July 29, 2014

Subject: **Geotechnical Response to City of Agoura Hills Review Sheet Dated April 18, 2014, Senior Housing Community, Vesting Tentative Tract Number 71742 (APN# 2061-001-025), 30800 Agoura Road, Agoura Hills, California.**

CITY OF AGOURA HILLS - GEOTECHNICAL REVIEW SHEET

GEOTECHNICAL CROSS SECTIONS

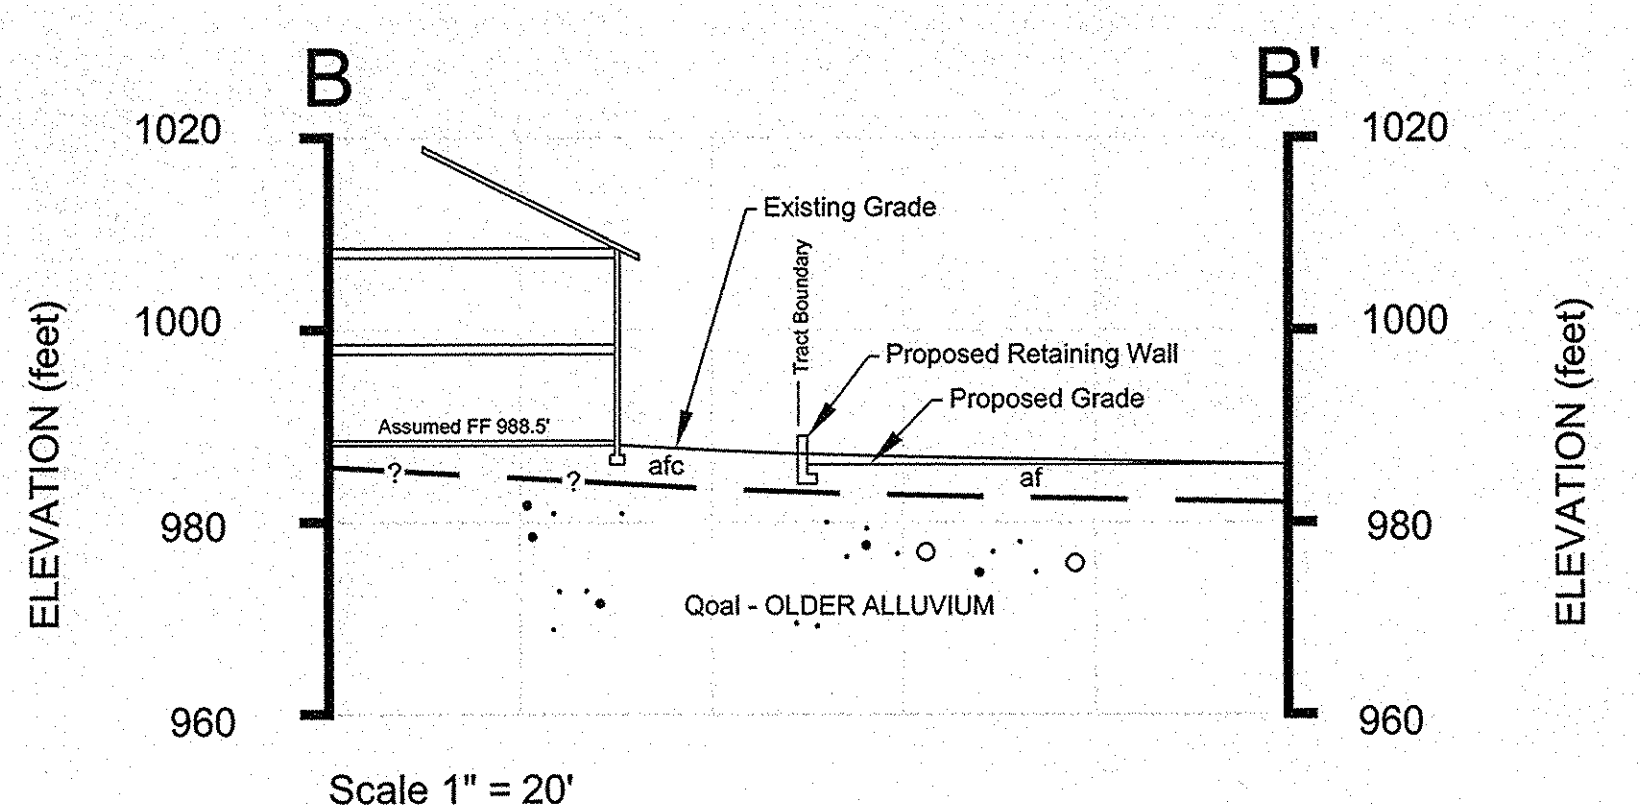
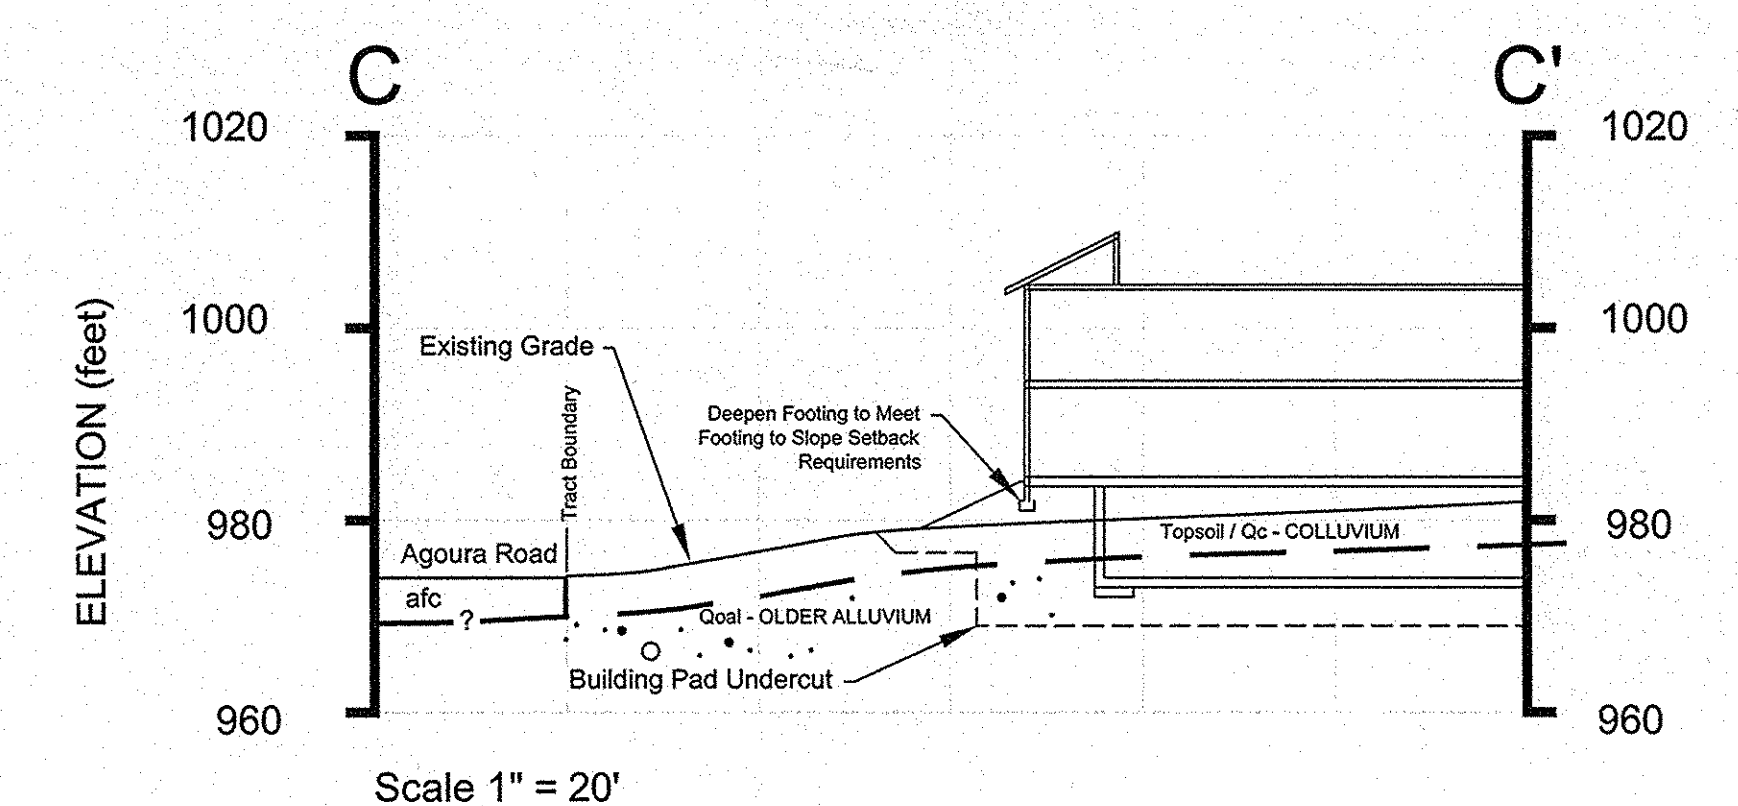
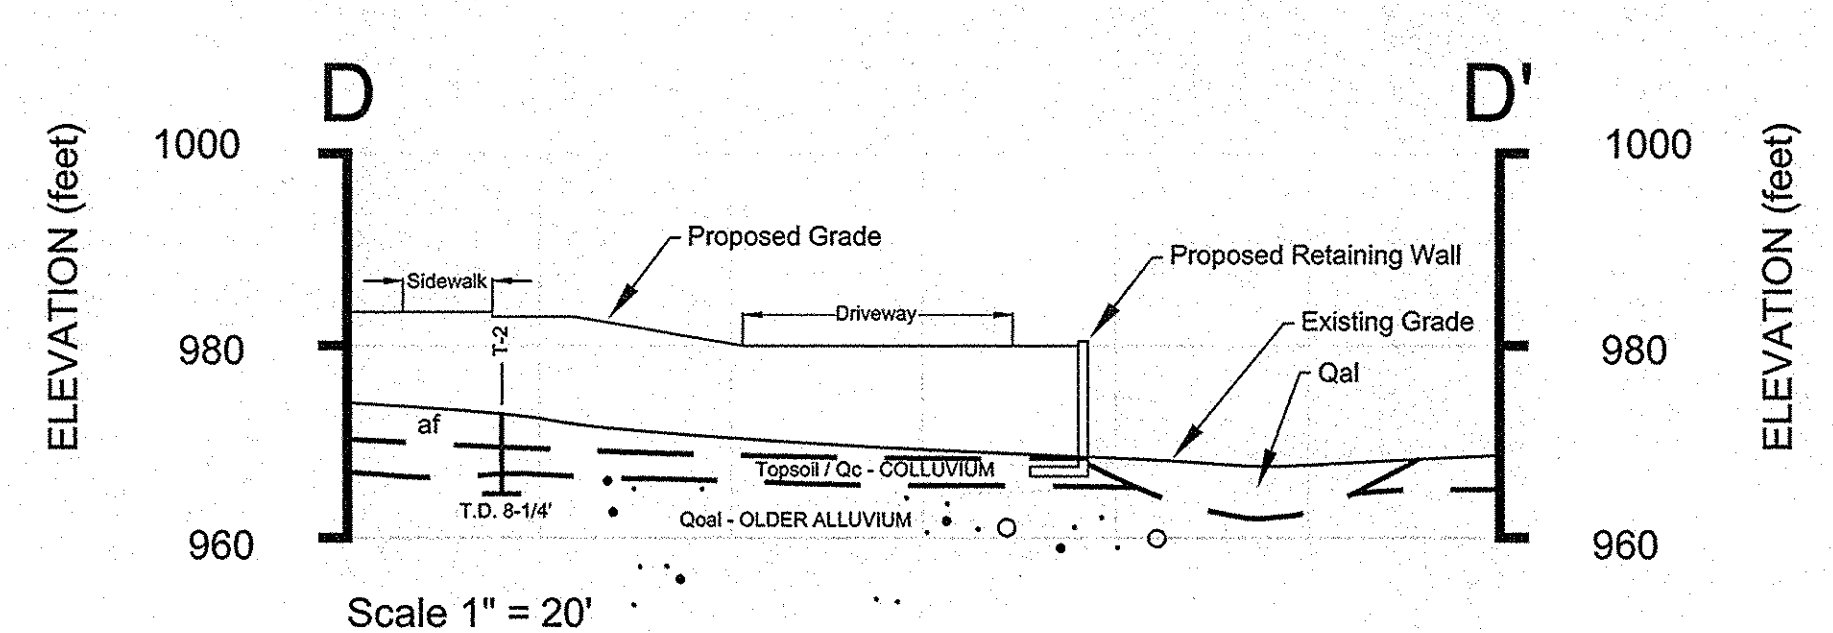
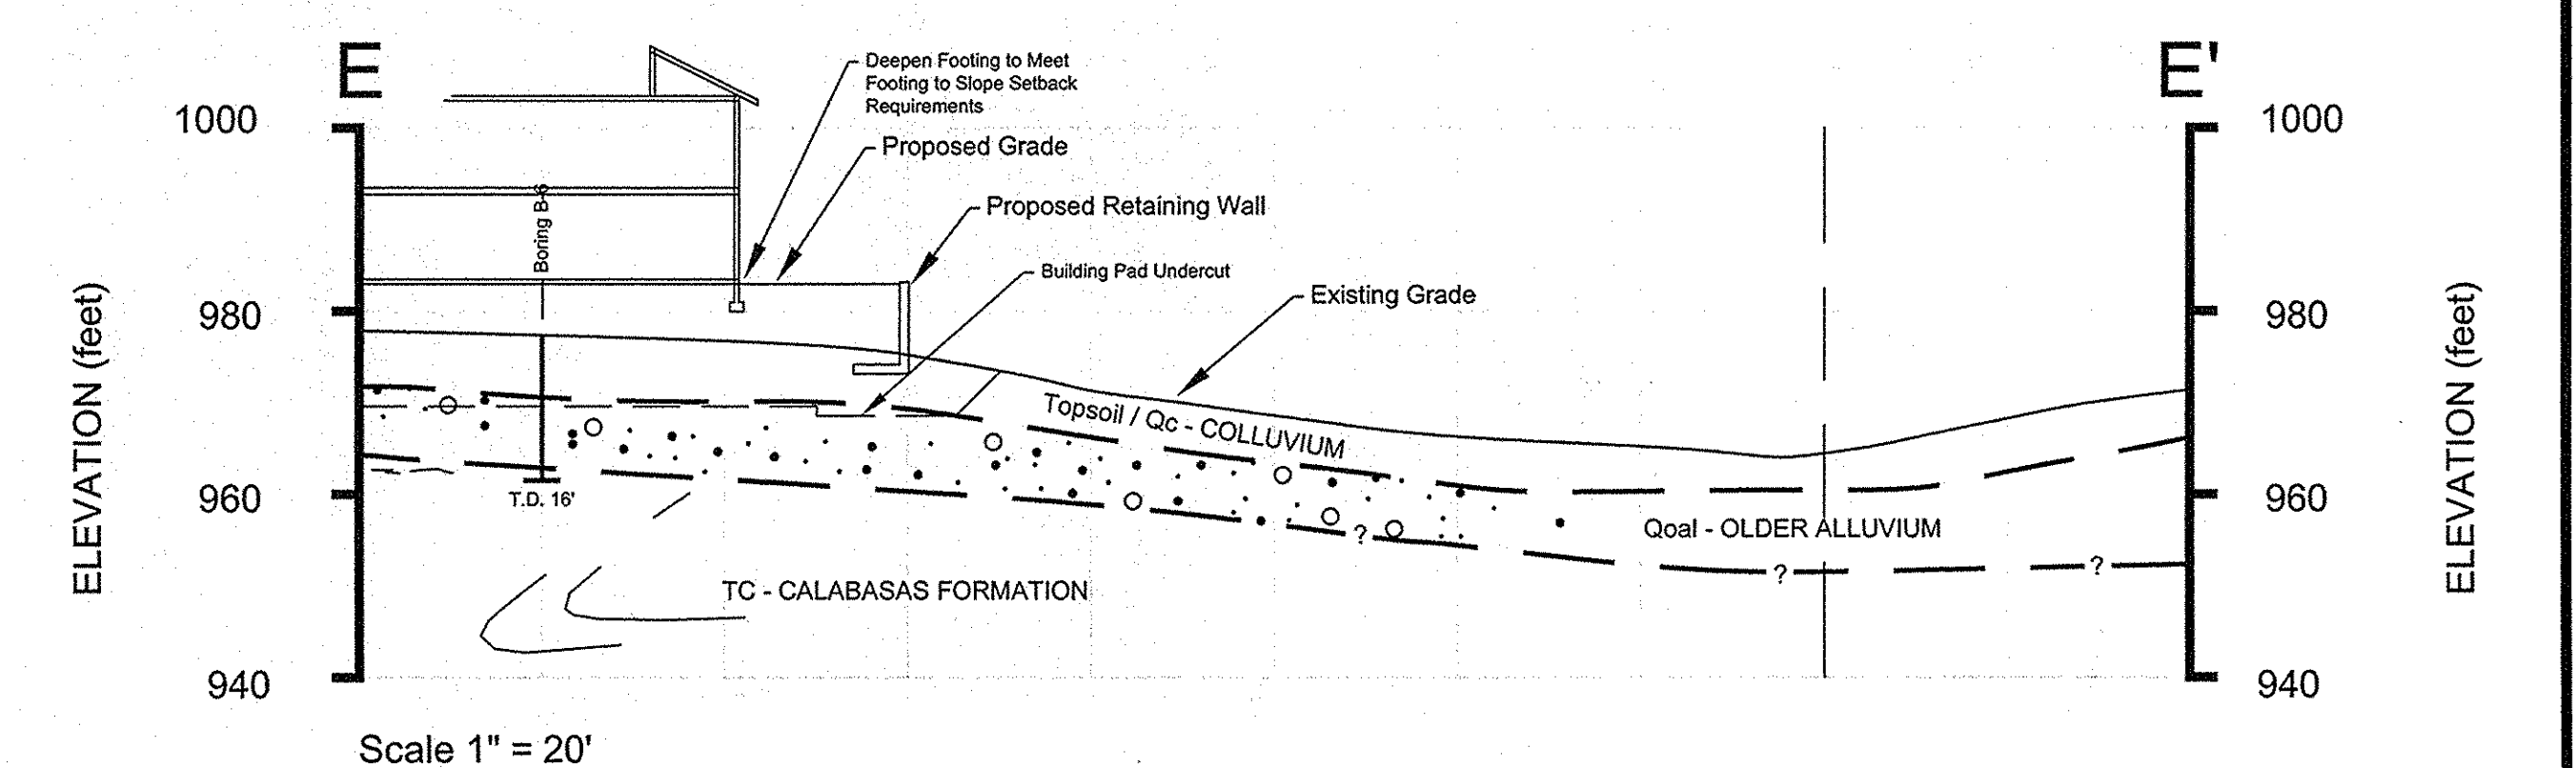
- a) The toe of fill below Building B extends along the property line. Colluvium in this area is depicted as being only a few feet thick on Cross Section A-A'. The basis for interpreting such a thin section of colluvium in this area is not clear, and is contrary to normal colluvial configurations (colluvial wedges tend to thicken in the down slope direction). The inclination of the colluvial contact appears to be constrained at about 13 to 14 degrees between borings B-2 and B-6. Immediately north of B-6, the contact is depicted on Cross Section A-A' as flattening to about eight degrees. This change in inclination is unconstrained. A down slope continuation of the 13 to 14 degree dip constrained between B-2 and B-6 would result in a colluvial wedge closer to about 20 feet thick below the proposed toe of slope. The consultant should discuss how the recommended removals (all colluvium) will be accomplished if a thick section of colluvium is encountered below the toe of the proposed slope.

The depth of the Colluvium was determined based on the thicknesses observed in the borings and backhoe trenches excavated on site, including the latest infiltration test pit IP-1. The thickness of the Colluvium observed in our northernmost borings B-1, B-5, and B-6 is 7, 3, and 6 feet, respectively. Boring B-5 is roughly 50 feet from the present toe of slope descending from Agoura Road. In addition, no colluvium was noted in trenches T-3 and T-4. The Colluvium is 1.5 and 2.5 feet thick in trenches T-1 and T-2, respectively. In the most recent excavation IP-1, only a 4.5 foot thick layer of Topsoil/Colluvium was encountered over the Older Alluvium. Therefore, there is sufficient data to indicate the thickness of Colluvium does not thicken significantly toward Agoura Road and an interpretation of the colluvial thickness should not be made based on contact inclination. No deep colluvial removal is anticipated along Agoura Road.
